Item 8.**Development Application: 503-505 Elizabeth Street, Surry Hills****File No.:** D/2020/20**Summary****Date of Submission:** 13 January 2020

Applicant: Wyong Depot Pty Ltd**Architect/Designer:** John Ferres**Owner:** Mr A J Tauszik**Cost of Works:** \$3,393,119.00

Proposal Summary: The application seeks consent for demolition of the existing buildings and construction of a new 7 storey mixed use development comprising:

Figure 9: Basement, ground floor and first floor plans

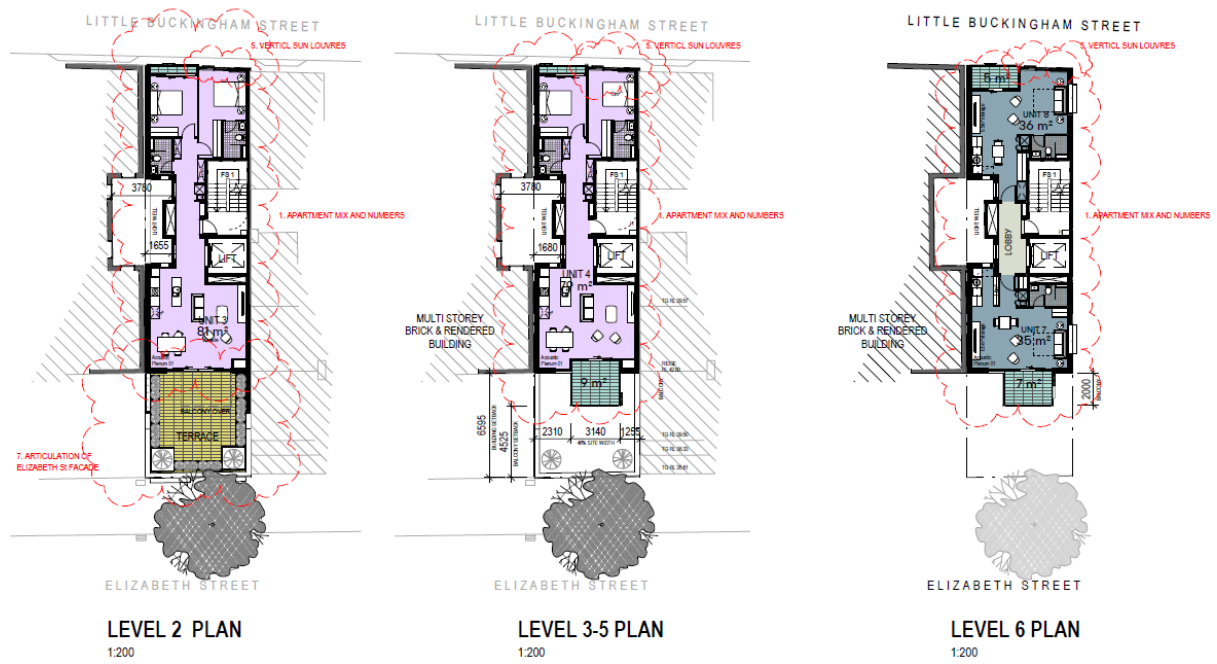
3. General Provisions	Compliance	Comment
3.1 Public Domain Elements	No	<p>The proposal includes poor interface with the public domain at ground level, particularly at the Little Buckingham Street frontage.</p> <p>On this frontage, a fire hydrant has doors that swing out onto the public domain. Additionally, a 1:20 ramp leads from the lobby to Little Buckingham Street with no landing at the top (at Little Buckingham Street). Both of these issues compromise the function of both the building and the public domain and are not acceptable.</p> <p>Council raised these issues with the applicant in its correspondence dated 12 May 2020. However, the applicant has not addressed these issues.</p>

3. General Provisions	Compliance	Comment
		The proposal also proposes 2 motorbike parking spaces accessed via Little Buckingham Street.
3.13 Social and Environmental Responsibilities	No	<p>Council's Urban Designer and Public Domain unit have raised the following CPTED concerns. It is considered that alternative design could provide an improved outcome for these issues:</p> <ul style="list-style-type: none"> • A recess is created behind the hydrant on the Little Buckingham Street façade, which creates potential for concealment or entrapment; • The inclusion of the driveway for 2 motorbike parking spaces occupies half the laneway frontage and removes opportunities for a safe and active laneway frontage. • No secure door is provided to the Little Buckingham Street entrance. Only a gate is provided, which is located 6.5m into the site.

108. Additionally, apartment 1 exceeds the maximum depth of open plan layouts of 8m, proposing an open plan area with a depth of 10.9m. It also does not comply with the minimum width for living areas (3.6m), proposing a width of 2.8m. This results in a long and narrow apartment with only a small window facing the internal lightwell providing ventilation to the kitchen/ dining area. This does not achieve sufficient cross ventilation, as the ADG requires inlet and outlet windows to have approximately the same area.

Figure 10: Levels 2-6 floor plans

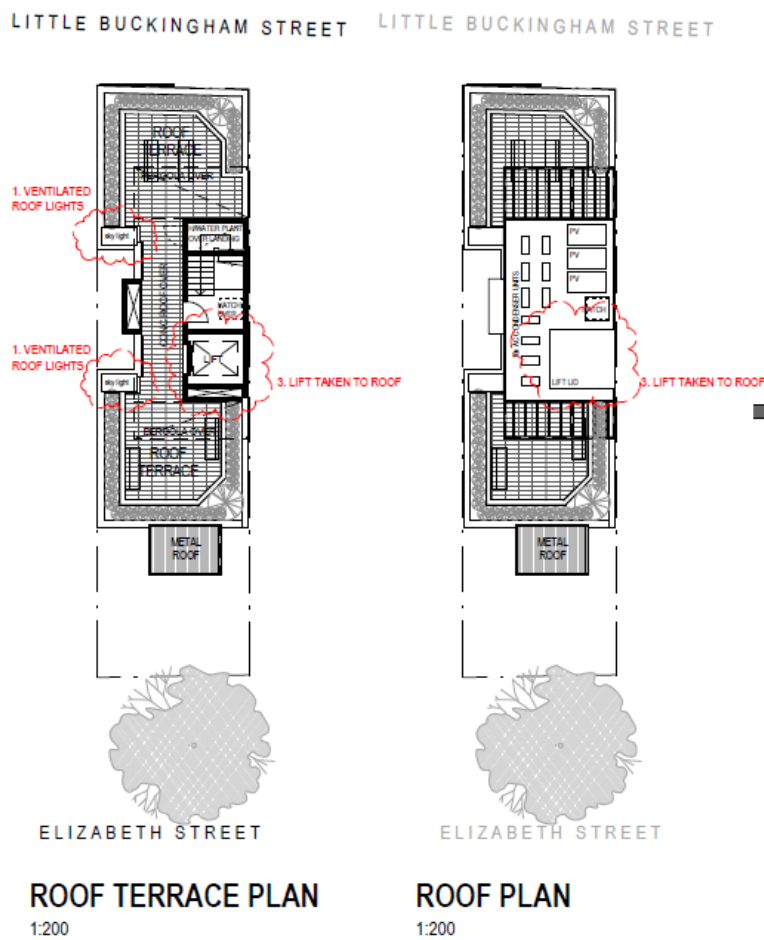
4E Private Open Space and Balconies	Compliance	Comment
Two bed apartments are to have a minimum balcony area of 10m ² with a minimum depth of 2m.		The two bedroom apartments on levels 3-5 have balconies with an area of 9sqm, which does not meet the minimum requirement of 10sqm for two bedroom balconies.
Private open space for apartments on ground level, on a podium, or similar, must have a minimum area of 15m ² and a minimum depth of 3m.	Yes	Apartment 3 on level 2 has a podium terrace which complies with the minimum area requirements.

4F Common Circulation and Spaces	Compliance	Comment
The maximum number of apartments off a circulation core on a single level is eight (8).	Yes	A maximum of 2 apartments are provided on a single level.
Primary living room or bedroom windows should not open directly onto common circulation spaces, whether open or enclosed. Visual and acoustic privacy from common circulation spaces to any other rooms should be carefully controlled.	Yes	Primary living room and bedroom windows do not open directly onto common circulation spaces.
Daylight and natural ventilation are provided to all common circulation spaces.	Partial compliance	Lobbies are only provided on levels 1 and 6. These lobbies have windows onto the internal lightwell. Lobbies are not provided to levels 2-5.

110. Part 4.2.3.3 of the DCP provides provisions for internal common areas.
111. The proposal provides common lobbies to apartments on levels 1 and 6, however no lobbies are provided on levels 2-5. This results in lift access opening directly into 4 out of 8 apartments within the building.
112. The absence of lobbies on these levels raises privacy and safety/security concerns (see Figure 19 below). It allows for the potential of other residents having a direct line of sight from the lift when it opens at each of these levels into apartments.

Figure 11: Roof terrace plan and roof plan

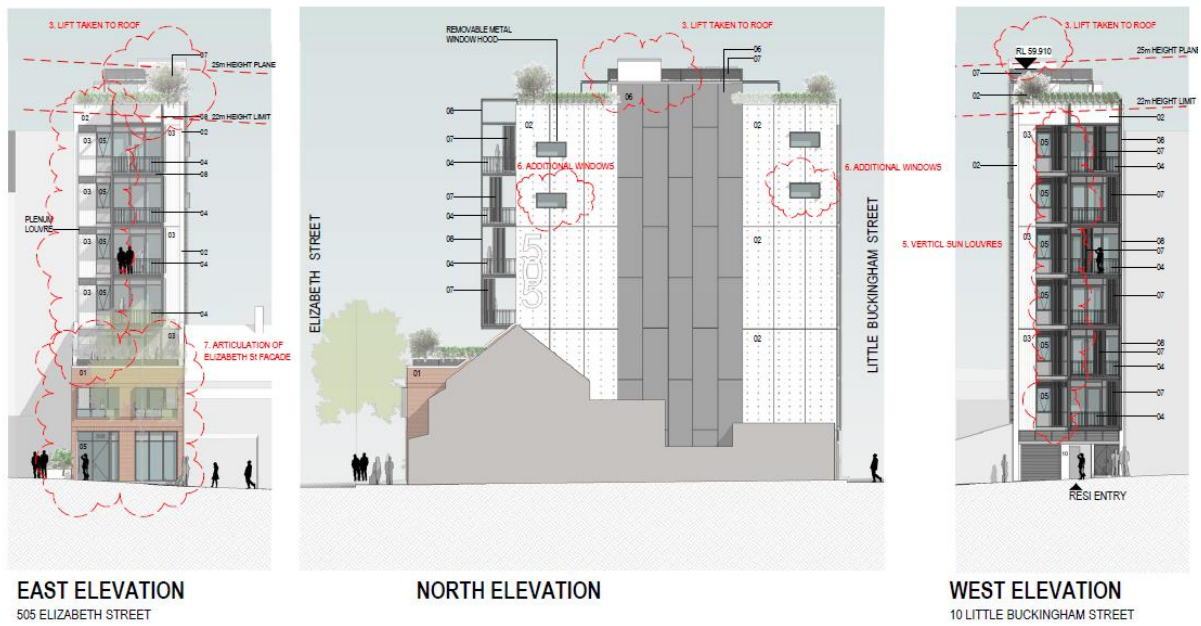
117. Communal open space on the roof top level is provided. This comprises two terrace areas measuring approximately 18sqm each (including planter boxes), which are connected by a covered corridor. Useable area (excluding planter boxes) measures 12sqm on the eastern terrace and 14sqm on the western terrace.

122. The roof terrace is designed to have a BBQ, picnic table and two chairs. Whilst this is sufficient for basic amenity, the applicant was advised on 12 May 2020 that further consideration should be made to ensure the roof top area has a high standard of finish and design. As an example, it was suggested that integrating the seating into the planter walls would create a more elegant solution than proprietary furniture.

123. No attempts were made by the applicant to revise the rooftop design to create a high quality communal open space. The poor design quality of the communal open space contributes overall to the failure of the building to exhibit design excellence.

Figure 13: Sections

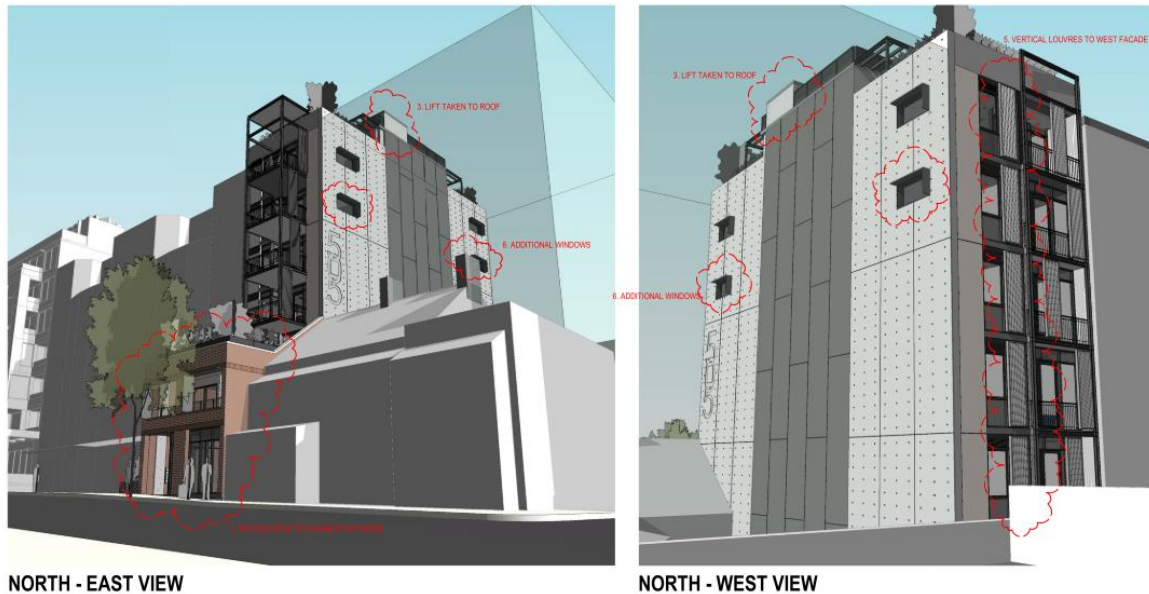
4C Ceiling Heights	Compliance	Comment
Habitable rooms: 2.7m	Partially complies	The section drawings are unclear as to the ceiling heights of habitable rooms, as only floor to floor dimensions are provided. When measured to scale, the ceiling heights appear to be approximately 2.6m.
Non-habitable rooms: 2.4m	Yes	Appears to comply.
If located in mixed use areas – 3.3m for ground and first floor to promote future flexibility of use.	No	The ground floor has a ceiling height of approximately 2.9m which does not comply with this requirement.

Figure 16: Eastern elevation on Elizabeth Street, with the maximum 22m height of building development standard in red

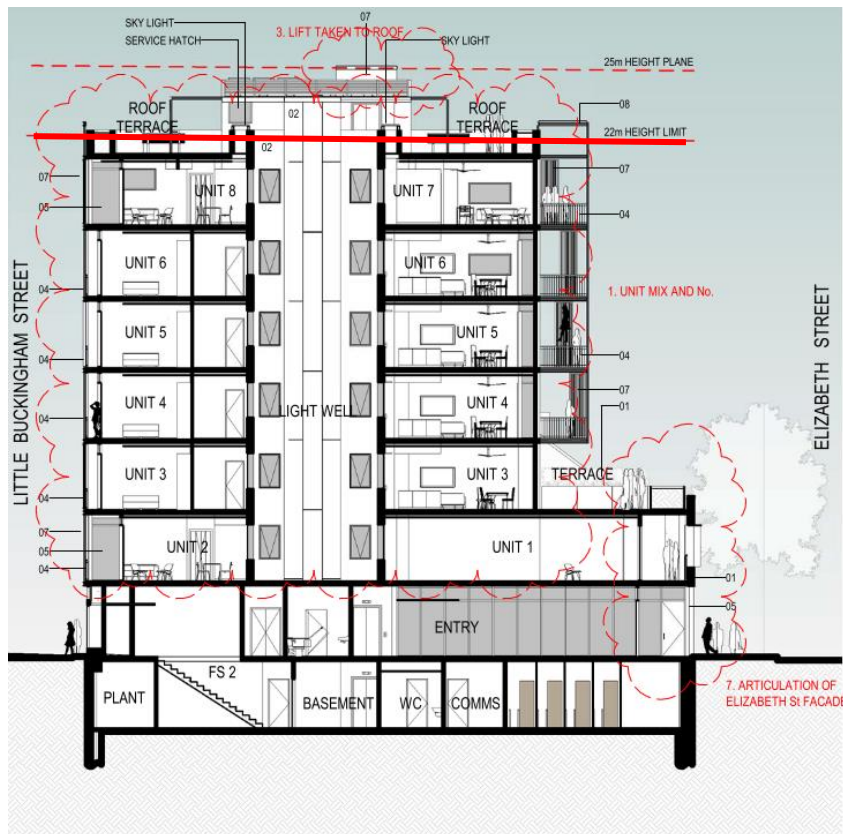
41. The site is subject to a maximum height of buildings control of 22 metres. The proposed development (as amended) has a height of approximately 25.3 metres (0.4m higher than the building as originally submitted). The development exceeds the maximum height control by 15%.
42. The extent of non-compliance with the height limit is shown in the figures below.

89. The applicant responded with amended plans submitted on 30 September 2020 which increased the extent of the height non-compliance.
90. The proposed building is overbearing when compared to the 2 storey contributing terraces immediately north of the subject site. Whilst this is inevitable to some extent, given the height and floorspace controls, this could be ameliorated by complying with the height controls and providing a more appropriate set back to Elizabeth Street.

91. The building also exceeds the height of the building directly south of the site by approximately 3.2 metres (exact heights are unclear on the architectural plans) and therefore does not provide an appropriate height transition from the building to the south to the 2 storey terraces to the north. This is inconsistent with the objectives of the height of building development standard outlined in Clause 4.3 of the Sydney LEP 2012, which include ensuring the height of the development is appropriate to the condition of the site and its context and ensuring appropriate height transitions between new development and buildings in heritage conservation areas.
